These amendments consist of changes to the Technical Specifications which revise the Administrative Controls, Section 6. The changes reflect corporate and plant reorganizations including the addition of an Assistant Station Manager, establishment of a Safety-Evaluation and Control group to replace the System Nuclear Safety and Operating Committee and the addition of a Shift Technical Advisor.

Amendment No. 69  
License No. DPR-32

SAFETY EVALUATION BY THE OFFICE OF NUCLEAR REACTOR REGULATION  
RELATED TO AMENDMENT NO. 69 TO FACILITY OPERATING LICENSE NO. DPR-32  
AND AMENDMENT NO. 69 TO FACILITY OPERATING LICENSE NO. DPR-37

VIRGINIA ELECTRIC AND POWER COMPANY  
SURRY POWER STATION, UNIT NOS. 1 AND 2  
DOCKET NOS. 50-280 AND 50-281

Offsite Organization for Facility Management and Technical Support

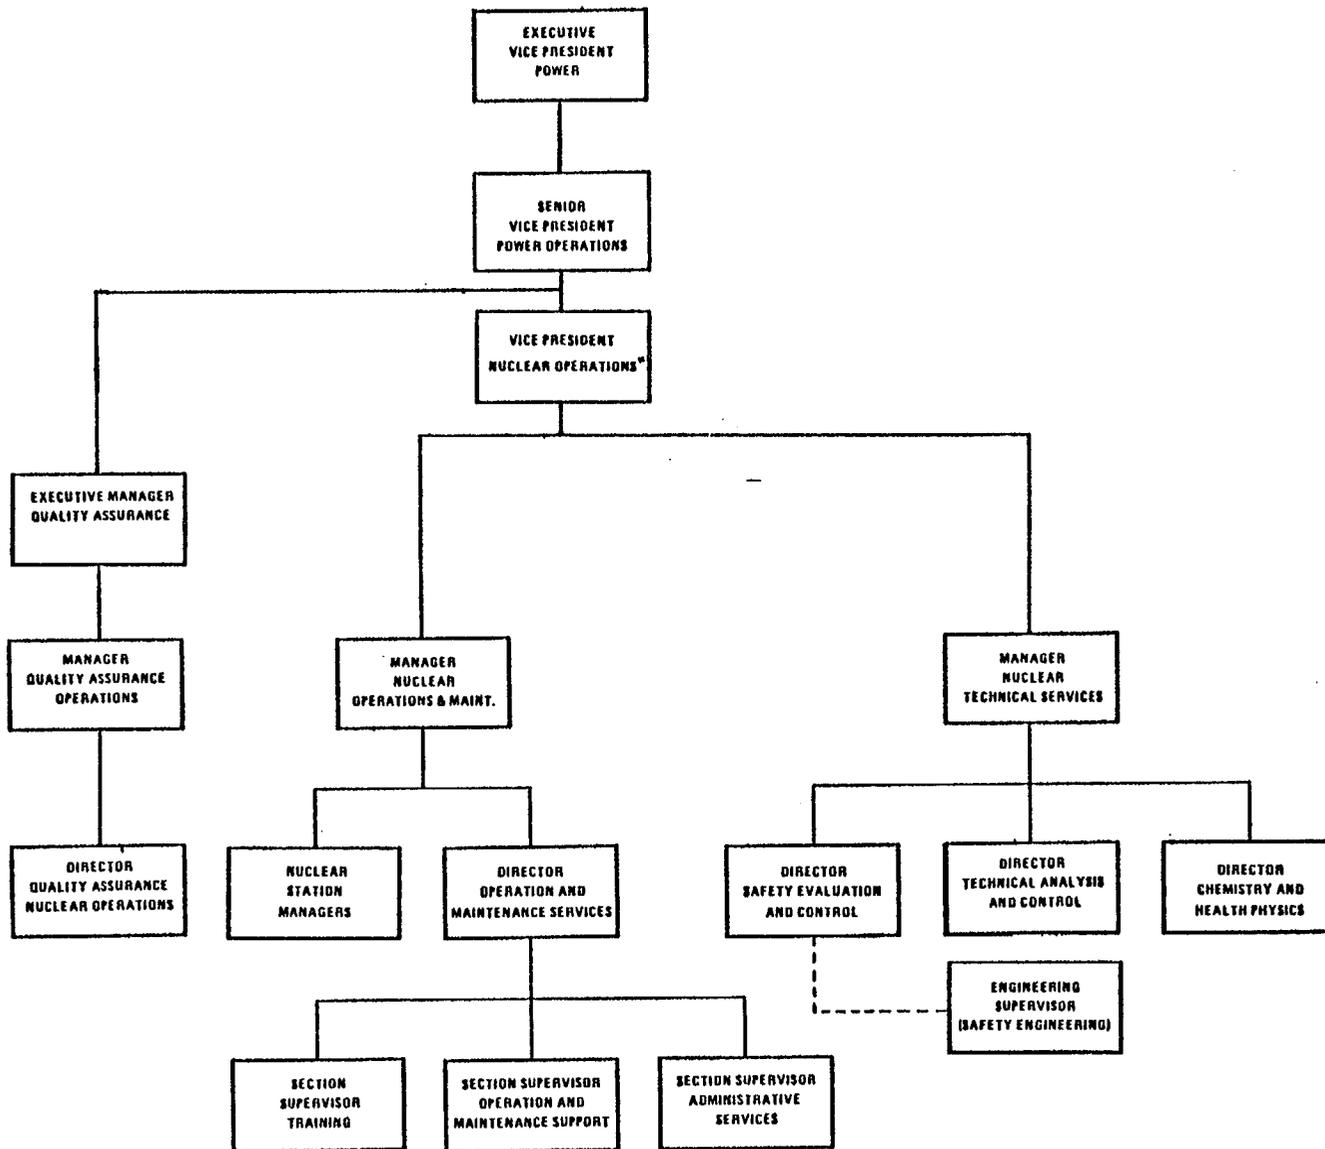
Technical Specifications Figure 6.1-1 has been revised to show the new structure of the offsite organization for facility management and technical support. Information provided by Figure 6.1-1 was previously provided by Figures 6.1-1 and 6.1-2. The previous positions of Senior Vice President-Power and Vice President-Power Supply and Production Operations have been deleted from the Technical Specifications. The deleted positions have been replaced by the Executive Vice President-Power, the Senior Vice President-Power Operations, and the Vice President-Nuclear Operations. All previous references to the Senior Vice President-Power and Vice President-Power Supply and Production Operations positions have been revised to reference either the Senior Vice President-Power Operations or the Vice President-Nuclear Operations positions.

As indicated by Figure 6.1-1, the Manager-Nuclear Operations and Maintenance and the Manager-Nuclear Technical Services replace the previous position of Director-Nuclear Operations. Both managers will report to the Vice President-Nuclear Operations. The Manager-Nuclear Operations and Maintenance has responsibility for the supervision of the Nuclear Station Managers. Both Nuclear Station Managers and the Director-Operation and Maintenance Services report to the Manager-Nuclear Operations and Maintenance. The Section Supervisor-Training, the Section Supervisor-Operation and Maintenance Support, and the Section Supervisor - Administrative Services will report to the Director-Operation and Maintenance Services. Reporting to the Manager-Nuclear Technical Services are the Director-Chemistry and Health Physics, the Director-Technical Analysis and Control, and the Director-Safety Evaluation and Control.

SURRY POWER STATION  
ORGANIZATION CHART

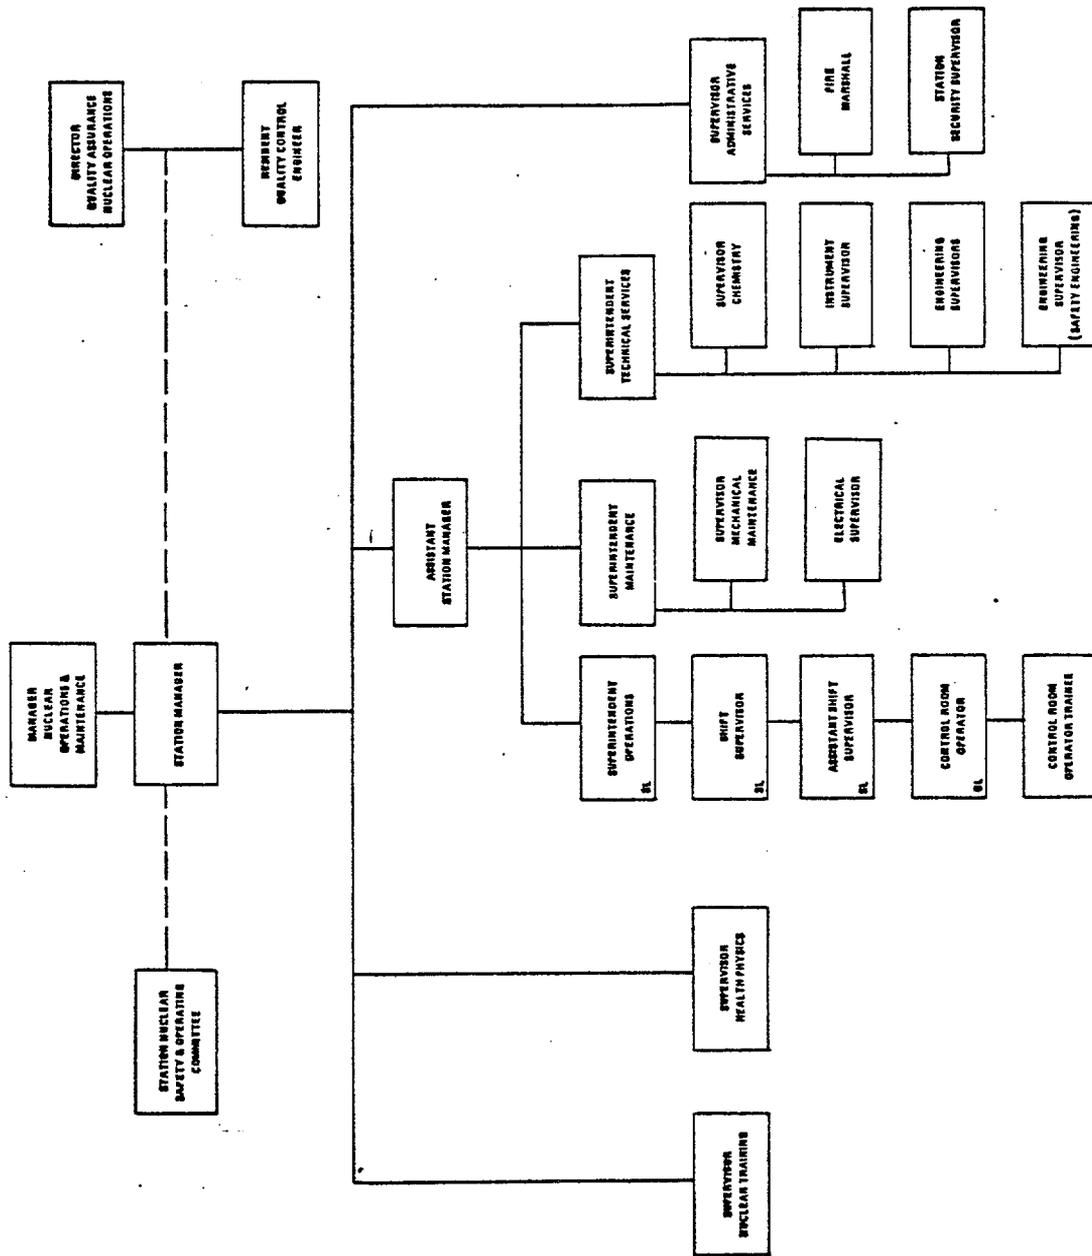
Technical Specification Figure 6.1-2 has been revised to show the new structure of the Surry Power Station organization. Figure 6.1-3, which previously provided this information, has been deleted. As explained above, the Station Manager reports to the Manager-Nuclear Operations and Maintenance. Our August 4, 1980 submittal (Serial No. 671) proposes revising Section 6.0 to add the new position of Assistant Station Manager to the Surry Power Station organization. The Assistant Station Manager will be directly responsible for the safe operation and maintenance of the power station. He will serve in a coordinating capacity to the Station Manager for the off-site activities of the Station. During the absence of the Station Manager, the Assistant Manager will act as the Station Manager. The Assistant Station Manager will also be the Vice Chairman of the Station Nuclear Safety and Operating Committee (SNSOC). The Superintendent-Operations, the Superintendent-Maintenance, and the Superintendent-Technical Services will report to the Assistant Station Manager. All three of these superintendents will remain members of the SNSOC.

The positions of Operating Supervisor and Auxiliary Operator have been eliminated from the organization chart. In addition, the position title of Assistant Control Room Operator has been revised to Control Room Operator Trainee. The positions of Maintenance Coordinator and Mechanical Supervisor have been replaced on the station organization chart by the position of Supervisor-Mechanical Maintenance. Both the Maintenance Coordinator and the Mechanical Supervisor report to the Supervisor-Mechanical Maintenance. Other title changes made to the organization chart include the change of Supervisor-Safety Engineering to Engineering Supervisor (Safety Engineering), the change of Engineering Supervisor to Engineering Supervisors to reflect the two positions of Engineering Supervisor-Performance and Tests and Engineering Supervisor-Design Changes and Projects and, the change of Training Supervisor to Supervisor-Nuclear Training. The Supervisor-Health Physics position has been shifted such that he will now report directly to the Station Manager instead of reporting to the Superintendent-Technical Services. The positions of Supervisor-Nuclear Training and Supervisor-Administrative Services will also report to the Station Manager.
